# Work Order ID 96728

Item Name: Crosstube Low Standard Aft

DRAWING NO. D212-664-247	TITLE CROSSTUBE ASS'Y (205 LOW AFT)	REV. B	<b>DART AEROSPACE LTD ENGINEERING ORDER</b>		D.E.O. NO. D212-664-247-B-1	SHEET NO. SHEET 1 OF 1	SCALE NTS
DRAWN 9	CHECKED A.S.S.	MFG. APPR. A.S.	APPROVED MD		DE APPR. A.S.		
DATE 11.07.15	DATE 11.07.20	DATE 11.07.21	DATE 11/07/21		DATE 11.07.21

**D212-664-247/-247B  
ASSEMBLY DETAIL**

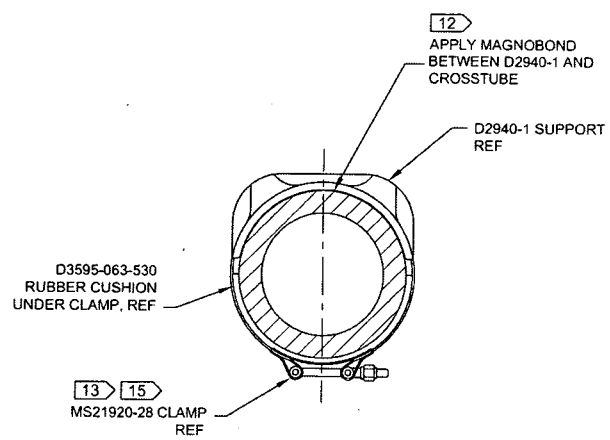
REPLACE MAGNOBOND WITH PROSEAL.

NOTE 12 & 15, SHEET 1 IS AMENDED AS FOLLOWS:

- 12) TO INSTALL D2940-1 SUPPORT: ABRASE MATING SURFACE OF SUPPORT AND CROSSTUBE WITH 180-GRIT SANDPAPER AND REMOVE RESIDUE WITH MEK (OR EQUIVALENT). APPLY A 0.04" TO 0.07" THICK LAYER OF PROSEAL 890 CLASS B-2 (OR AMS-S-8802 CLASS B-2) SEALANT TO MATING SURFACE OF SUPPORT.
- 15) TORQUE CLAMPS 80 TO 100 IN-LB. ENSURE AT LEAST 1.5 THREADS SHOWING IN SAFETY AND THAT NUT HAS NOT BOTTOMED-OUT AFTER TORQUING. **PRIOR TO PACKAGING, RE-CHECK TORQUE ON CLAMPS AFTER PROSEAL 890 SEALANT HAS CURED FOR 72 HOURS.**
